Capital Facilities Planning

Addendum 3 – Questions and Answers

To: All Bidders
From: Sayim Malik
Project Manager, Capital Facilities Planning
Re: Project SU-022723 - Phase 3 Bathroom Rehab Project
DATE: JUNE 26, 2023

2 FIRST FLOOR PLAN - ELECTRICAL POWER & FIRE ALARM
E-103.00 SCALE: 1/4" = 1'-0"

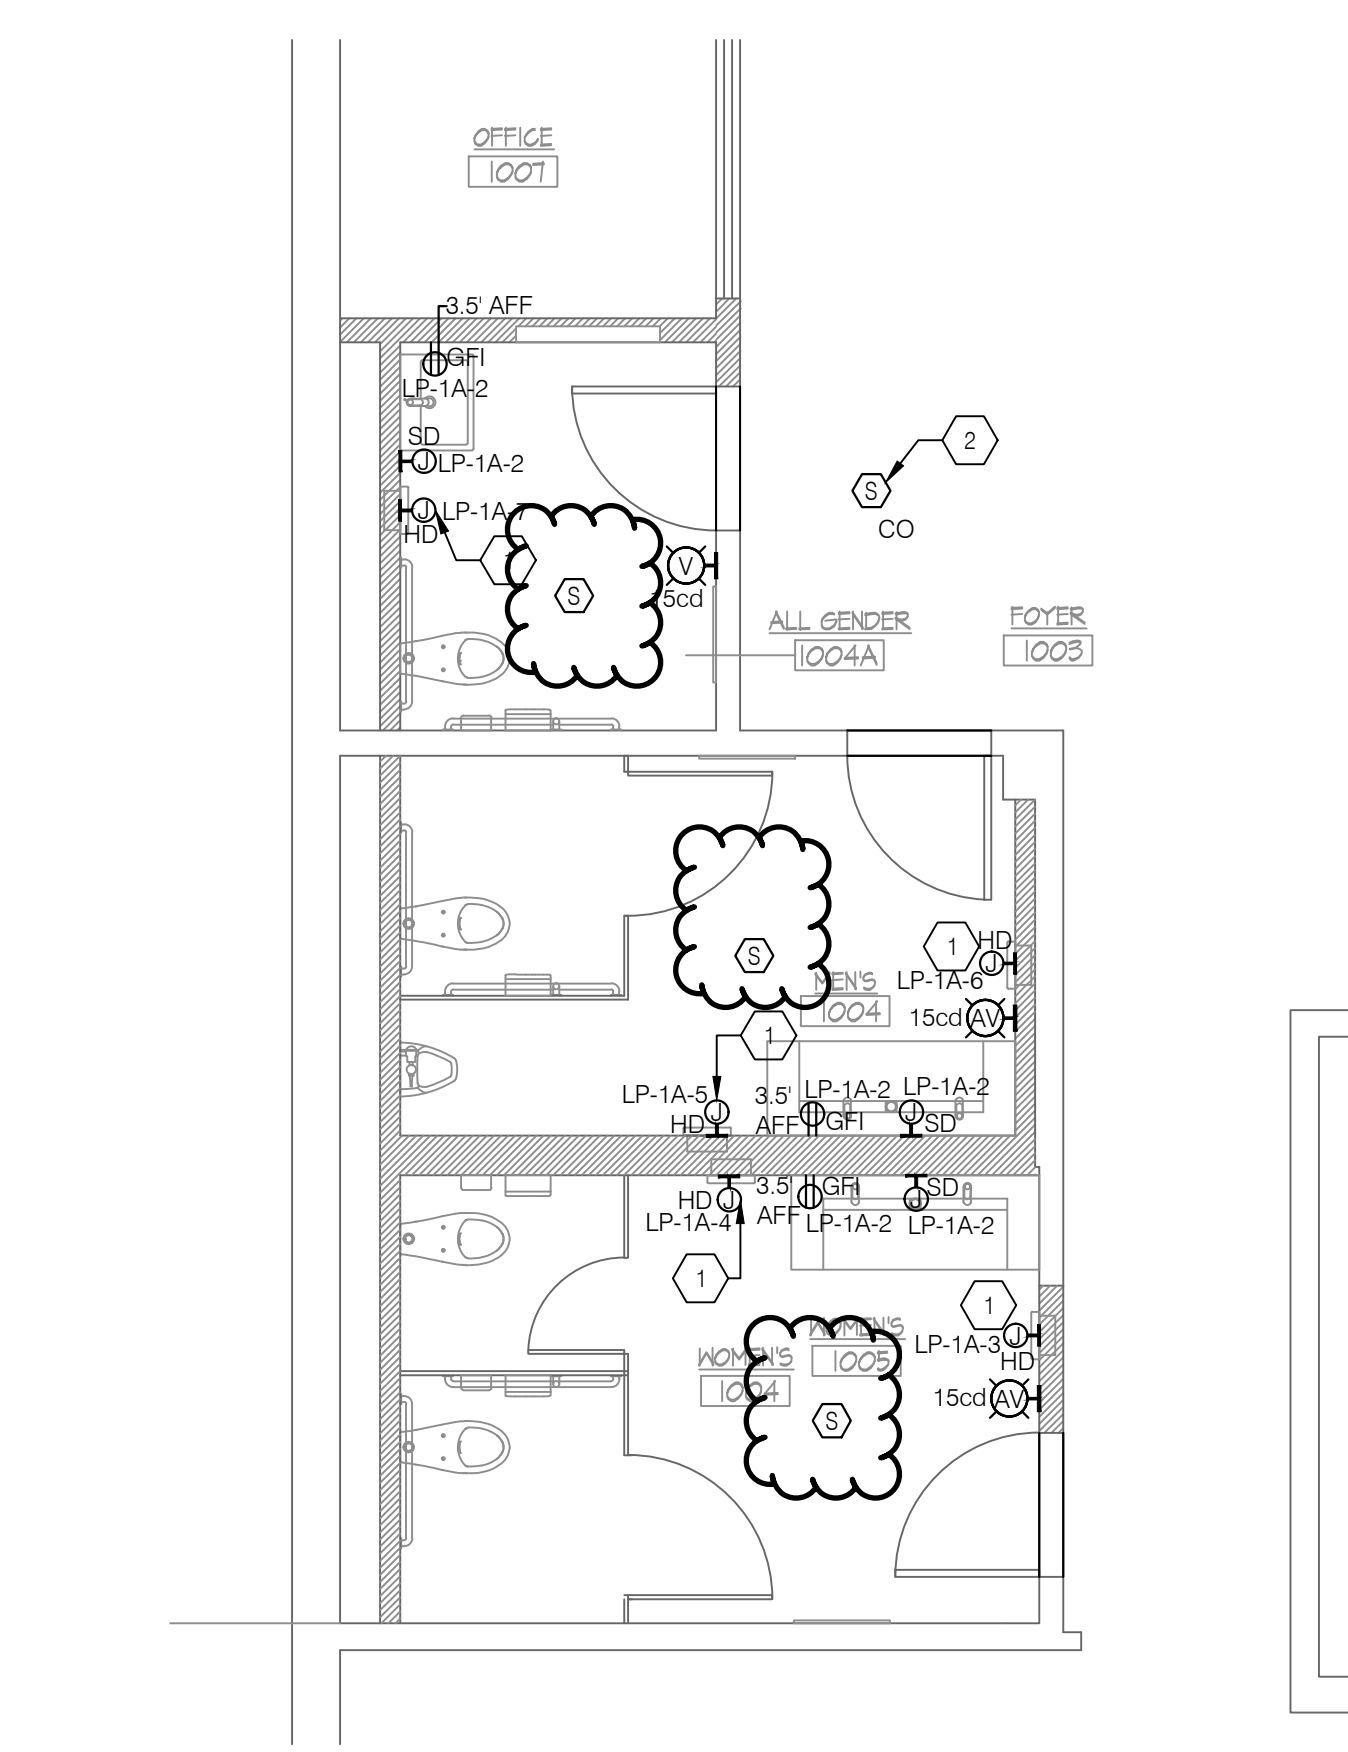
- Question 8: Campus Center South provide a Key Plan to Scale showing the Area of Work and the Electric Closet.
- Answer 8 *Key plan is indicated in the title-block on this sheet. Electrical room has been called out for reference. Refer to E-103.*

- Answer 11: *Please note that all EM fixtures are battery backups.*
- Question 12: Drawing E-103.00 Sheet Key Note #2-provide a Key Plan to Scale identifying the location of the nearest Emergency Panel.

- Answer 12: *Please note that all EM fixtures are battery backups.*
- Question 13: Drawing E-501.00 Detail #3 Partial Electric Risers-Panels are shown three phase yet the Panel Schedules on Drawings E-601.00, E-602.00 and E-603.00 depict Panels as single phase. Clarify three phase or single phase panels.

MAIN DINING HALL -
ELECTRICAL PLANS

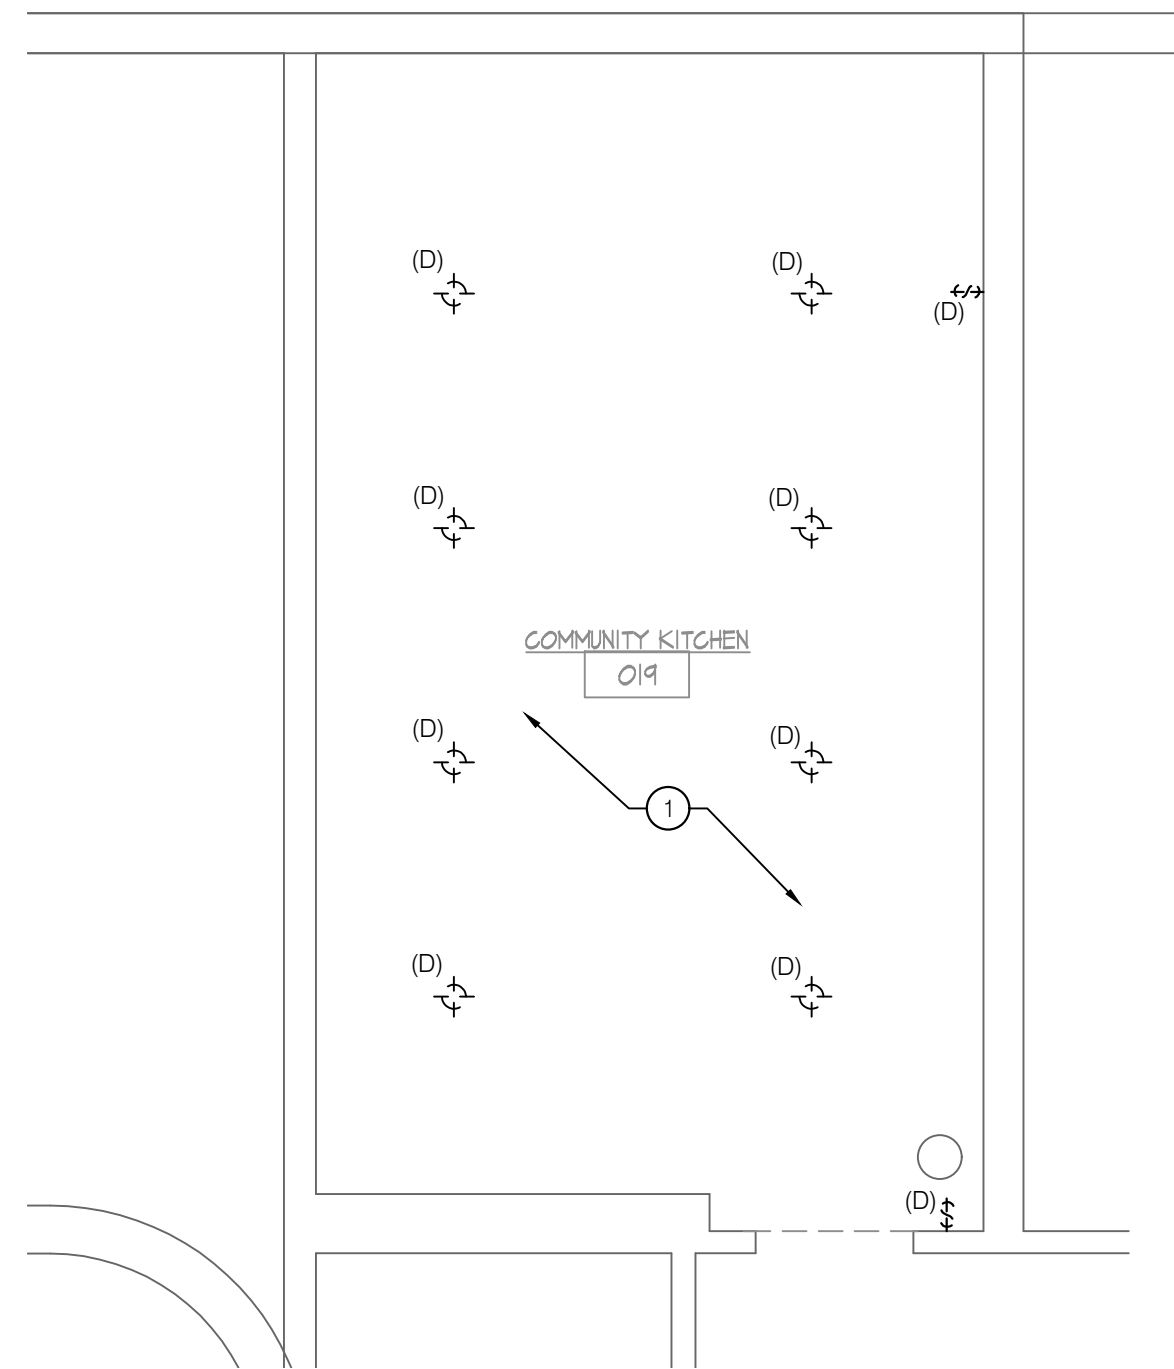
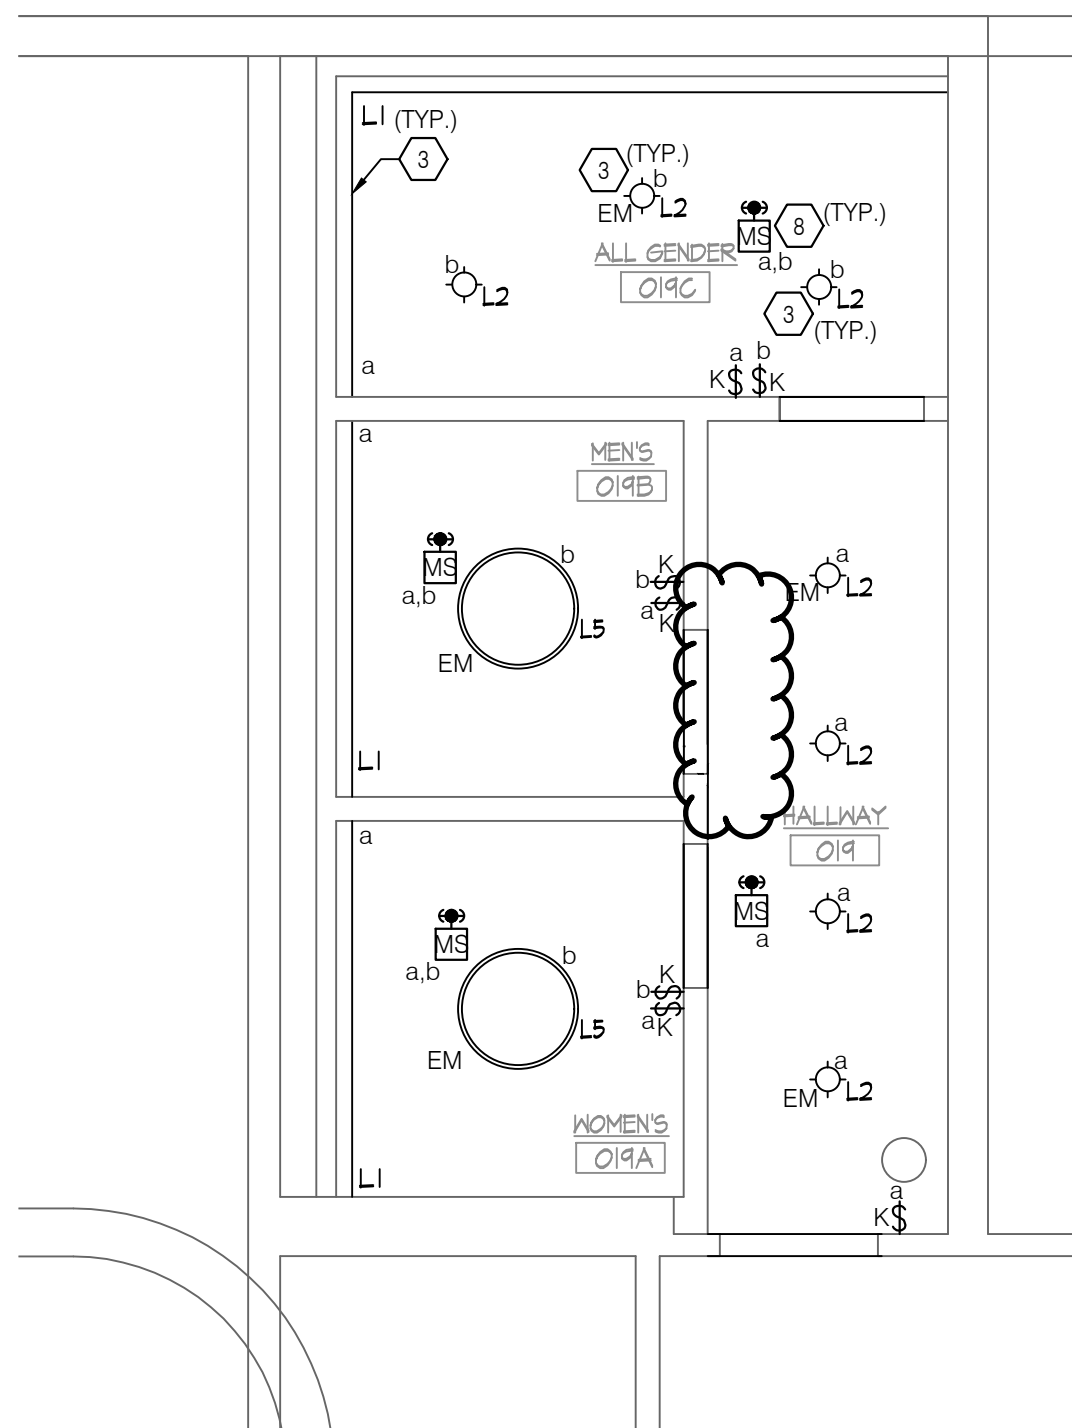
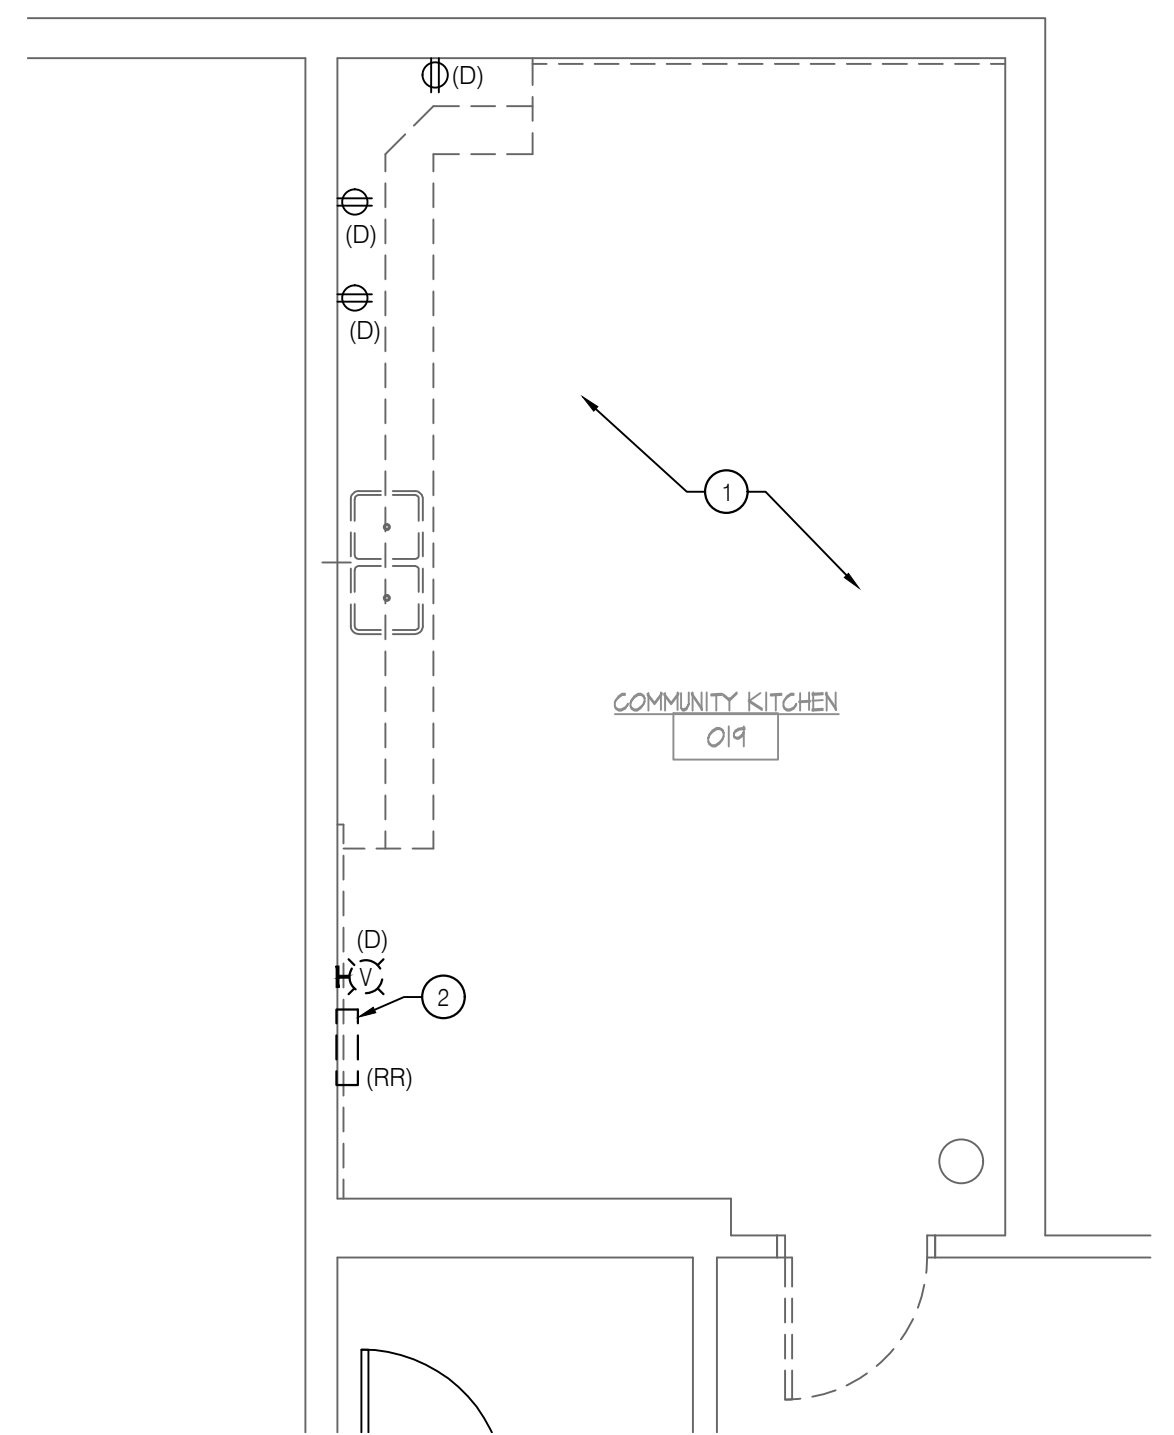
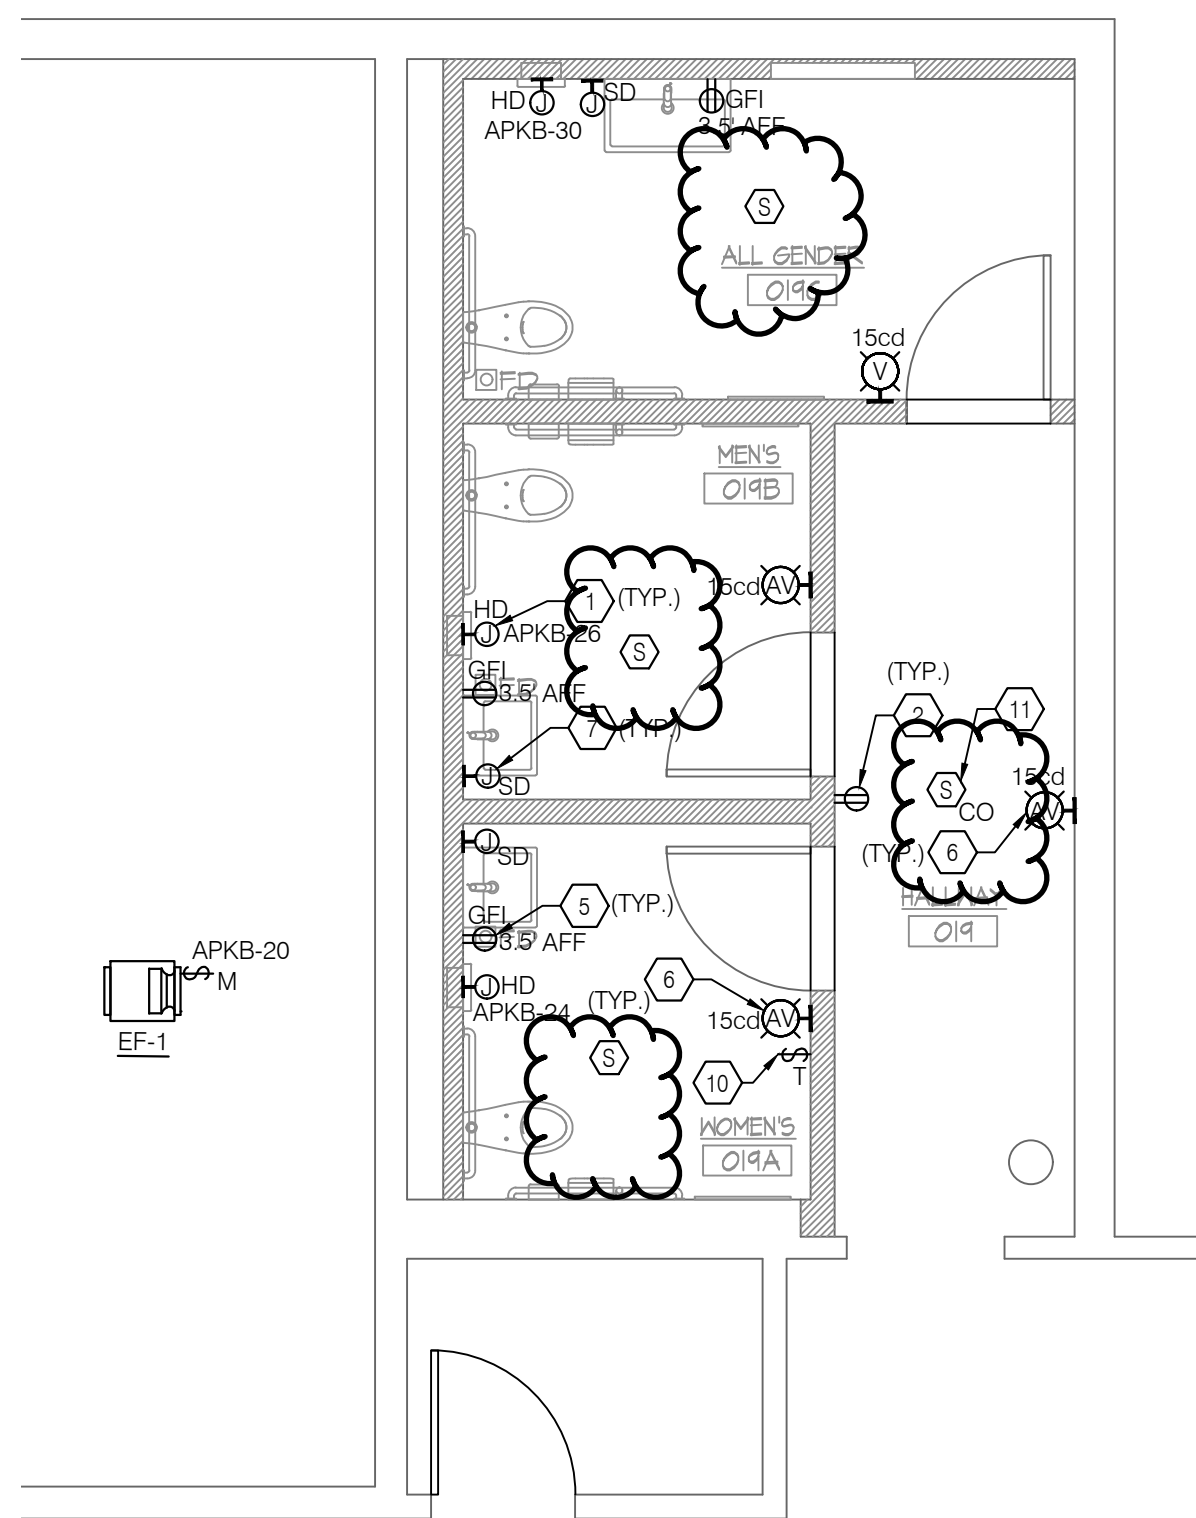
- Question 9: Main Dining Hall provide a Key Plan to Scale showing the Area of Work and the location of existing Panel board APKB within the existing Electric Closet.

- Answer 9: *Panel APKB is located in Room 029. On panel schedule, it was identified that there are spares available. Indicated circuits on plan are for reference only. Contractor to verify exact circuit numbers and to trace existing demolished circuits, re-use existing circuits to feed new loads. Note that additional circuits are available in nearby panels: Panel APKC.*
